22/P3620 Mitcham Gasworks Site Western Road Mitcham CR4 3FL

Mitcham Society comments

May 2024

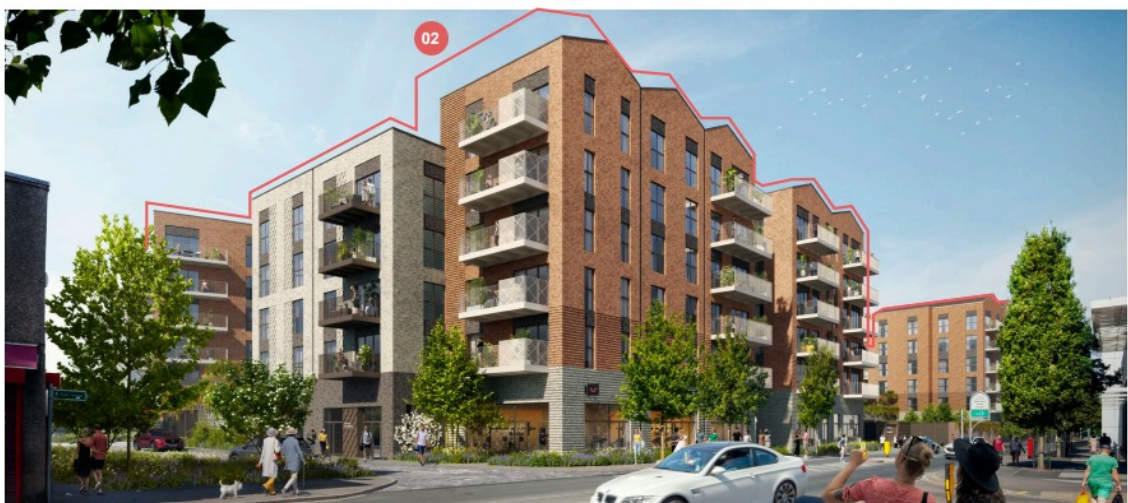
- e. The PRS which it has now been decided can be moved from its original location, is to be housed in an enclosed building that will front onto Western Road and sit in the centre line of the development. It will form one flank of the main entrance to the development: about as unwelcoming a design as it is possible to conceive both for those entering the development and those looking on from Western Road.
- f. Hay Drive open space has yet again been co-opted by the developer to give the impression they are creating open space which, in fact, already exists. An image showing Hay Drive open space but not the fence which exists in real life between it and the development can be found in the revised Design and Access statement, page 35 – below – boundary of development site in bottom image, people using green space of Hay Drive open space in foreground of upper image.
